DENVER HEALTH PAVILION 'I' RENOVATION

RECORD DRAWINGS

Denver Health Pavilion I renovation

Addendum #7 description

1 CONSTRUCTION PLAN - LEVEL 1

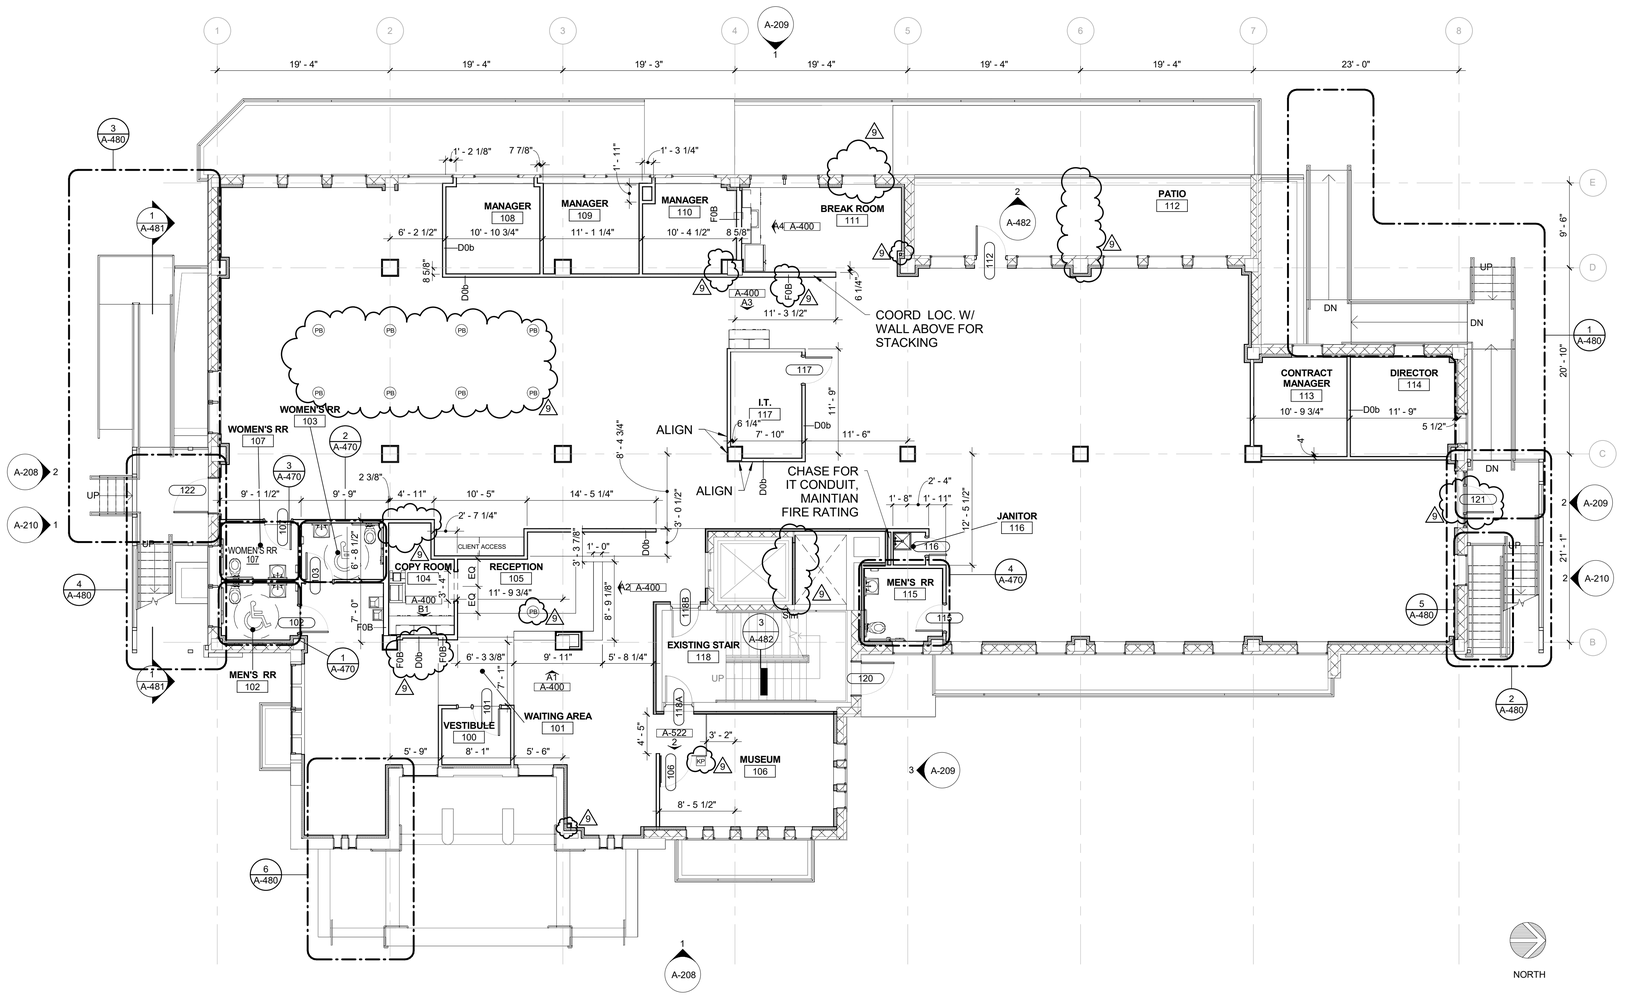
Due to scheduling and cost, the scope of the elevator renovation work has been reduced. The full modernization was going to delay the project, so it has been scaled back to a renovation of the elevator finishes only. A full description from the elevator manufacturer can be seen on sheet A-101.

ELEVATOR REVISED RENOVATION SCOPE

- Remove the existing mechanical or Infrared safety edge and related equipment.
- Supply and install new transmitter and receiver units.
- Mount the power supply unit on the top of the elevator car and connect to the receiver and transmitter.
- Perform all necessary interfacing with existing door operator.
- Test operation and return the unit back into service. Door Operator Replacement & Car Doors

- Disconnect all wiring and remove the existing door operator and door lock assemblies.
- Provide a new upgraded high performance, door operator complete with limit control, resistor bank and terminal box, pulleys, motor, drive arm, and gate switch.
-
- Install New interlock assemblies for each hatch door complete with new keeper lock, pickup rollers, and pickup arm.
- Perform all necessary engineering to interface the new door operator with the existing elevator control system and wire interlocks.
- Adjust the lock assemblies and door operator settings to attain the most efficient safety and performance standards.
- Submit the design submissions to the local governing authorities for the alteration to the elevator.
- Clean and check all car and hatch door tracks to ensure smooth operation. Note: Price does not include replacement of door tracks, hangers or rollers.

- Remove the existing handrails
- Apply attractive new wall panels on three walls in a design you select.
- Provide a new ceiling and lighting fixtures in a design of your choice.
- Clad the existing front returns, car jambs, and transom in a #4 stainless steel finish.
- Install a set of new #4 Stainless Steel Car Doors
- Rebalance Car as necessary
- Permit, test, and inspect
- Flooring to be provided by others if required

1 REFLECTED CEILING PLAN - LEVEL 1

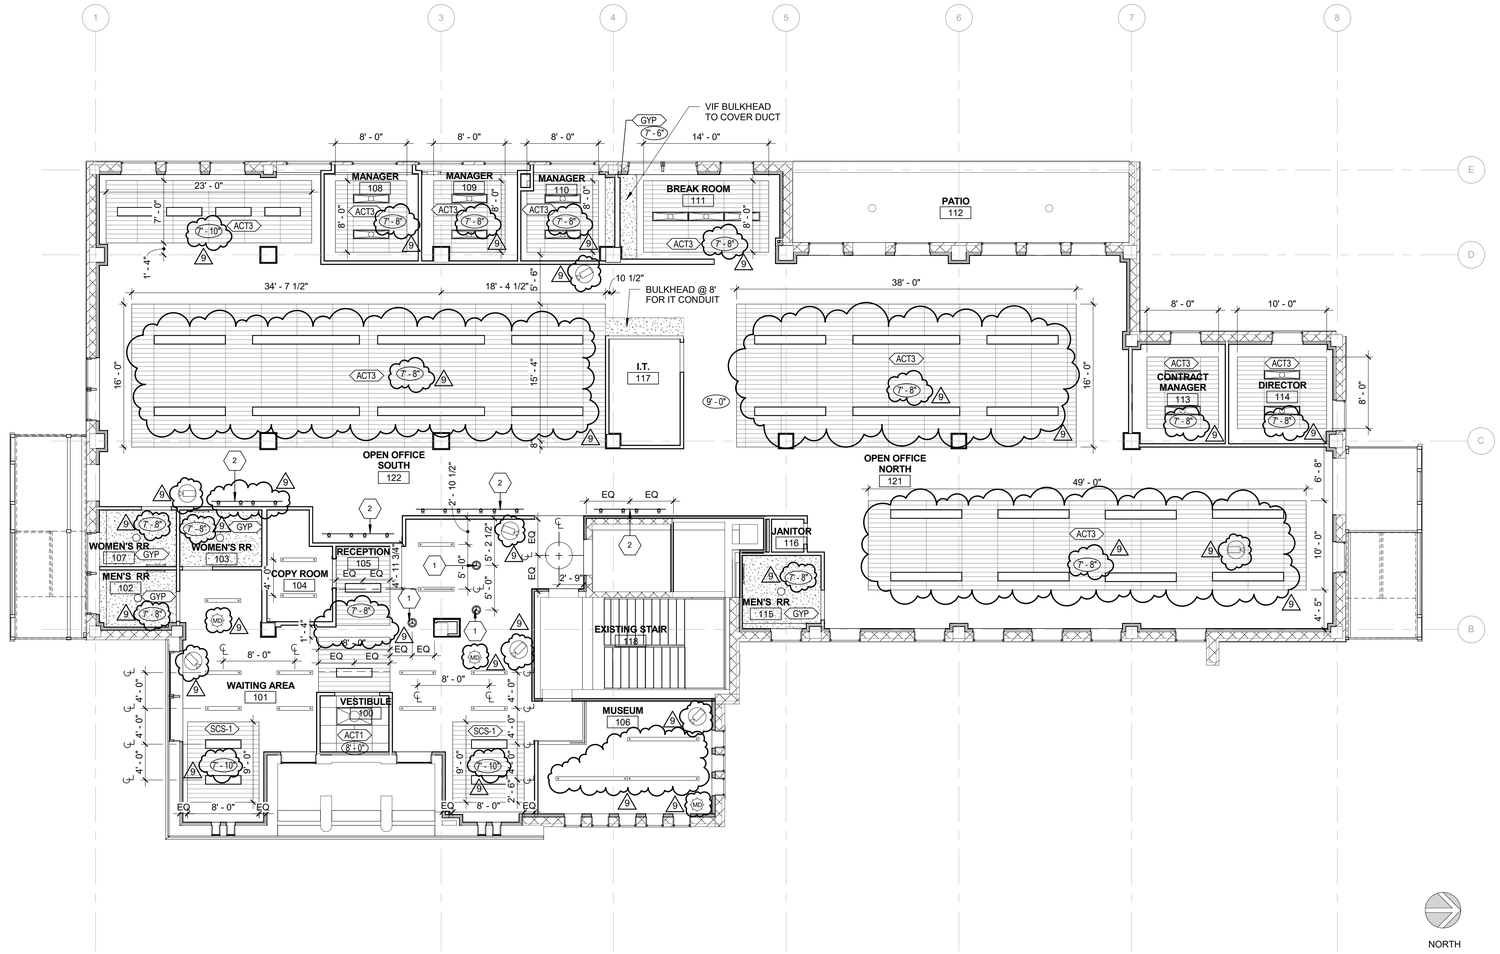
Due to coordination between the electrical, mechanical, and fire sprinkler trades, changes have been made to the dropped ceiling “clouds”. The height of these assemblies has been reduced to 7’-8” to the bottom face of finish. The orientation of the score lines has been rotated to run north/south instead of east/west. This has also resulted in changed quantity of light fixtures in order to fit into the new orientation and allow space for passage of duct and sprinkler lines. This is shown on all reflected ceiling plans.

1 FINISH FLOOR PLAN - LEVEL ONE

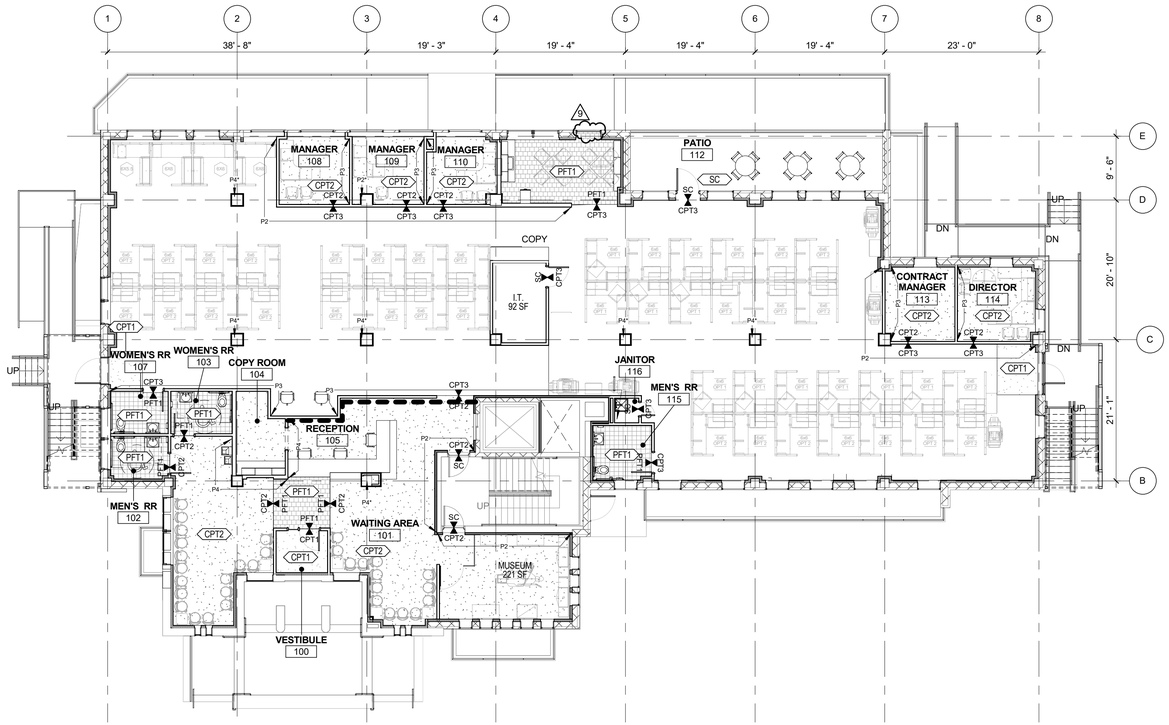
Due to comments from the code officials, the wood ceiling finish material has been changed to a veneer product with a Class A flame spread rating. See finish schedule on sheet A-601.

SCS1 WOOD CEILING
Armstrong Woodworks Linear Veneered #6460W1 Plank nominal 6" module 96"x 5-1/4"x3/4" with factory applied black fleece on each plank to cover ¾" reveal; NRC 0.50 min. with bioacoustic jute fiber black matt infill panel #5823 24" x24"x5/8"min.; Composite Class A Fire Performance for interface with 12' HD Linear Carrier #5371 with integral clips factory applied. Accessories: Woodworks 6" Trim # 5660W1 with real wood veneer to match panel and aluminum substrate. Plank and trim veneer to be selected from manufacture's standard offering not including bamboo. Note: Edge of plank to rest inside bottom leg of continuous unbroken trim. Stagger ends of planks and utilize edge banding #6408 to match on all exposed edges. Allow for ¾" expansion joint every 24' run of plank. Include 3 access panels 16" x 24" as designated on plans. Install per manufacturer's installation instructions BPLA-297442-615.
